ARROWSOUTH PROPERTIES LIMITED - PRIVATE PLAN CHANGE REQUEST

The purpose of this correspondence is to formally respond to the Council Request for Additional Information dated the 5th of August 2026 (**2nd RFI**). This correspondence should be read in conjunction to the additional information (and revised Request) supplied by APL to the Council on the 15th of July 2026 that dealt with the Request for Further Information (**1st RFI**) dated 9 April 2026.

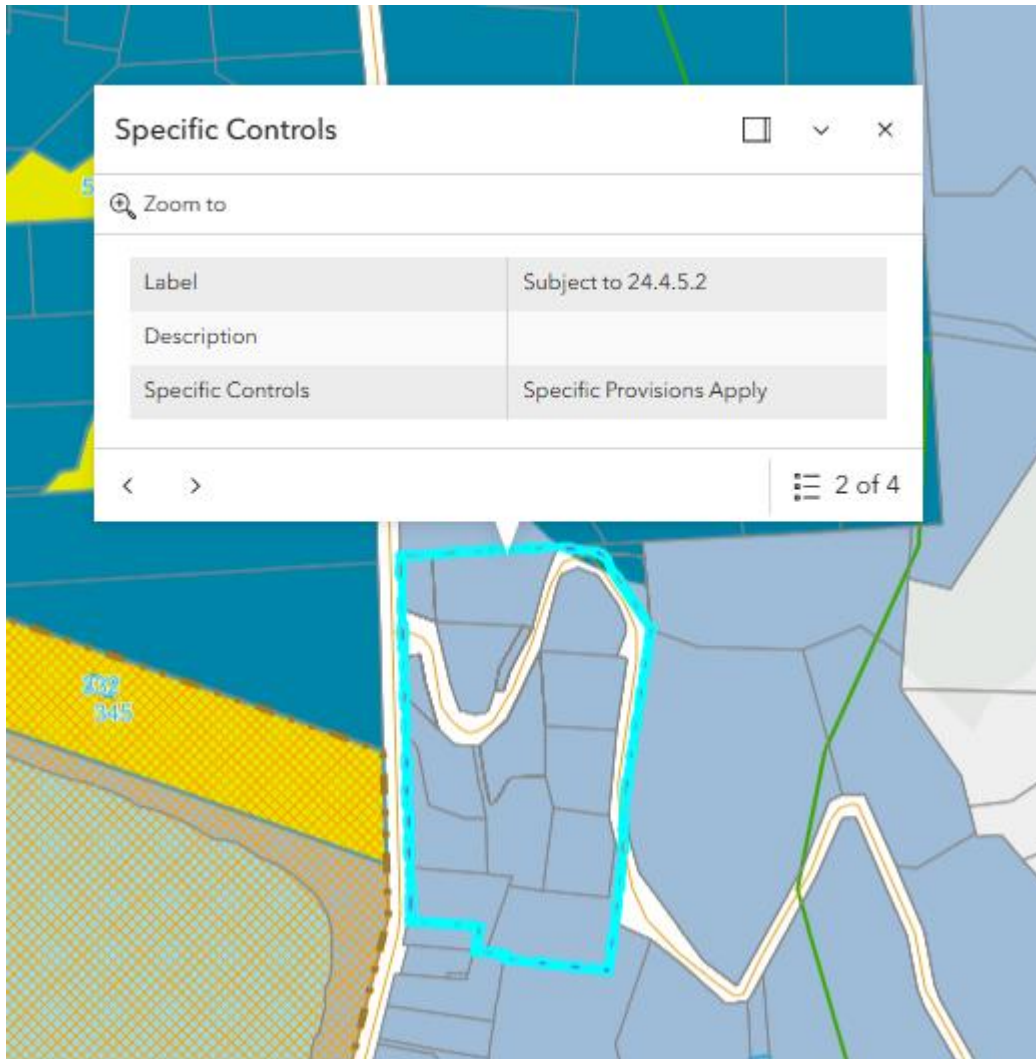
- d. A method to identify the land within the McDonnell Road - Suburban Residential Zone, either through an amendment to Chapter 27 or through a mapping annotation on the Planning Maps. This method should be included in the s32 report and plan amendments, with an appendix showing these provisions and/or mapping updates to the PDP.*

The updated Proposed Zoning Map (Appendix G) indicates the proposed zoning arrangement for the Site.

As outlined in the Request, it will be appropriate to introduce an additional PDP planning map overlay/demarcation to clearly indicate the land that will be subject to

the bespoke policy framework for the Site/McDonnell Road - Suburban Residential Zone.

An example of a PDP mapping 'Specific Controls' for specified land is indicated below:

On the basis that the rezoning of the Site is successful as proposed, it is the Council's role to update the PDP mapping system, based on the mapping supplied and approved within the Request. The update to the PDP mapping will include the demarcation of the McDonnell Road - Suburban Residential Zone via a Specific Control, as per the other PDP example indicated above. As such, it will be clear for users of the PDP as to the bespoke provisions that apply to the Site.
